Driver Precomp Proposal, Review

00-227r7 23-Aug-00
Paul Aloisi - TI 320 410 427 485 500 533 600 700 800 Millivolt drive

Drive tolerance calculation

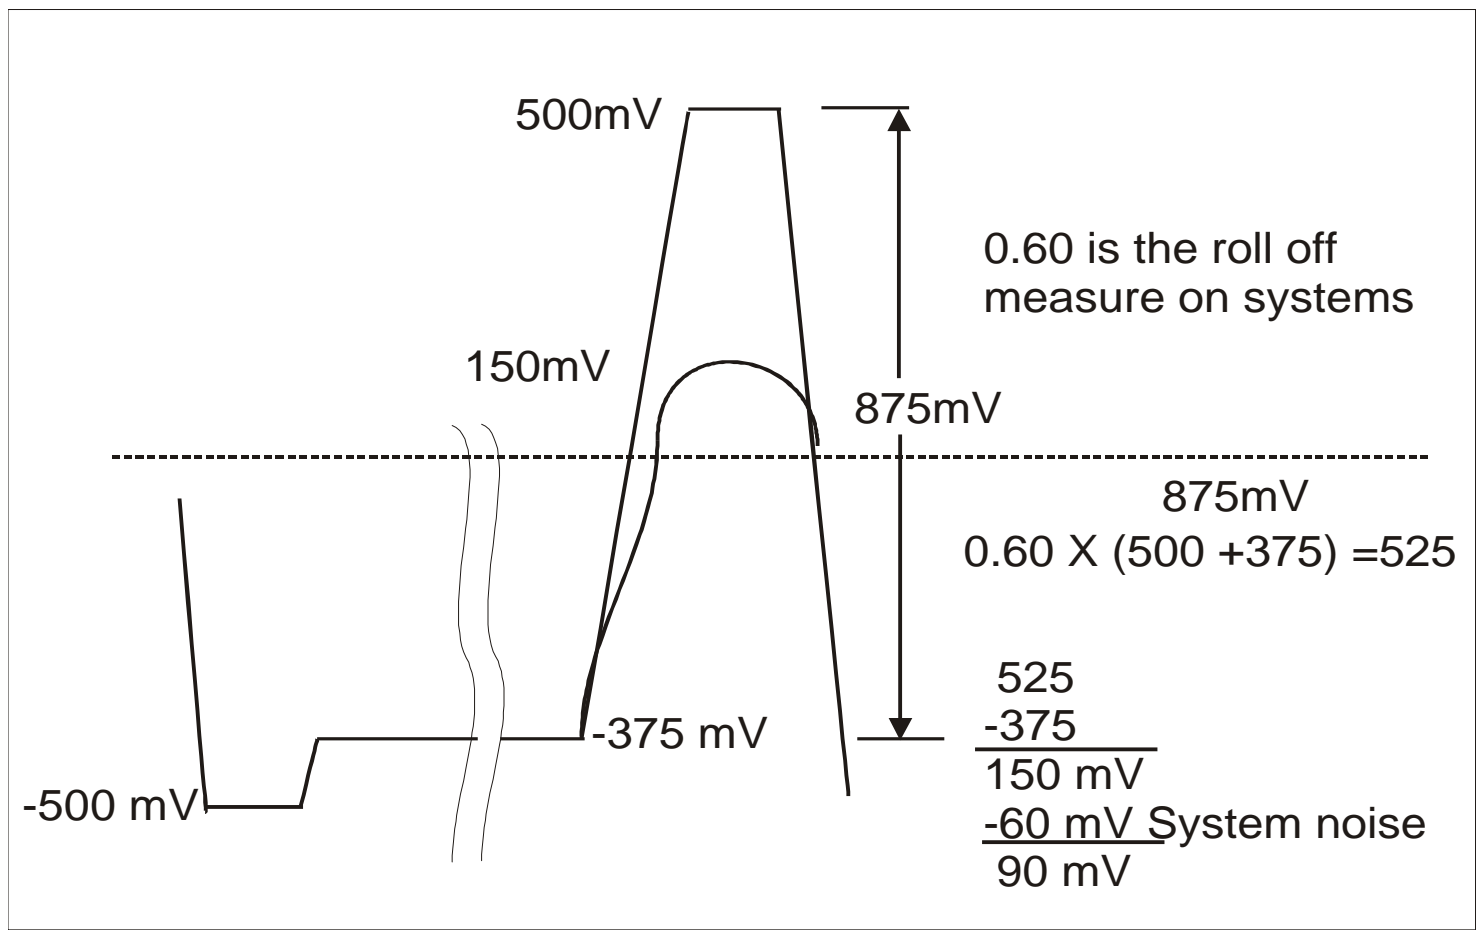
No Fall back - toleranced 15%	-24.8	-14.9	-13.03	-6.65	-5	-1.37	6	17	28	
Precomp off	-28.32	-19.41	-17.727	-11.985	-10.5	-7.233	-0.6	9.3	19.2	10% DC loss from cable, connectors and terminators
Improved Tolerance driver asymmetry										-30 mV receiver required - Adaptive Active Filter - no eye pattern
Cable roll off to 60% signal -60 mV crosstalk & Noise										Recommended -100 mV Adaptive Active Filter

Adaptive Active filter required

10 mV receiver needed minimum

Recommended 0 mV Adaptive active filter

Seagate numbers limits configuration

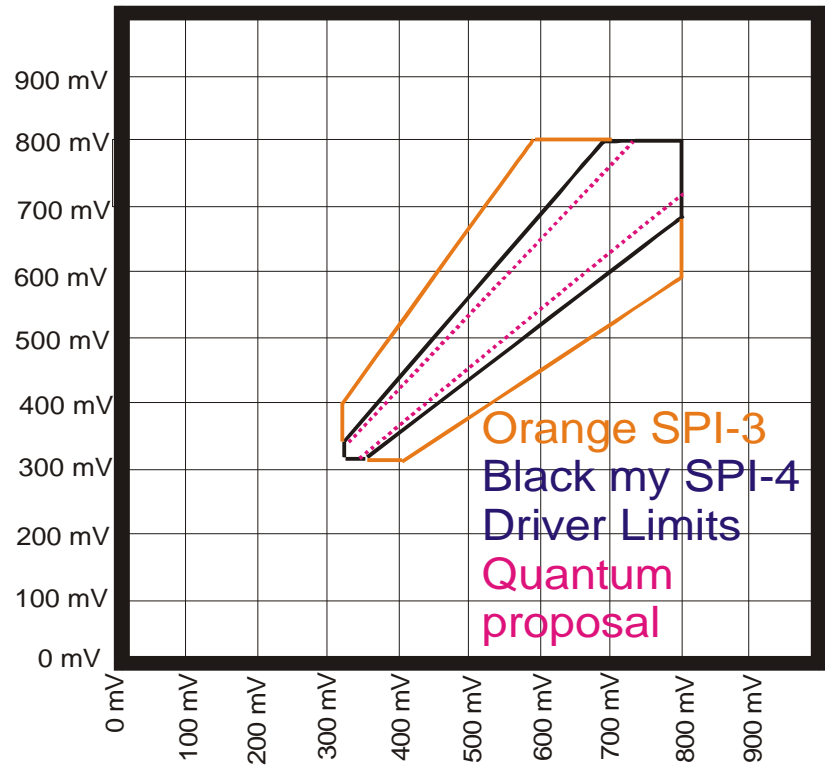
SPI-3 receiver levels are marginal, limits system loss

70 mV Receiver needed for minimum
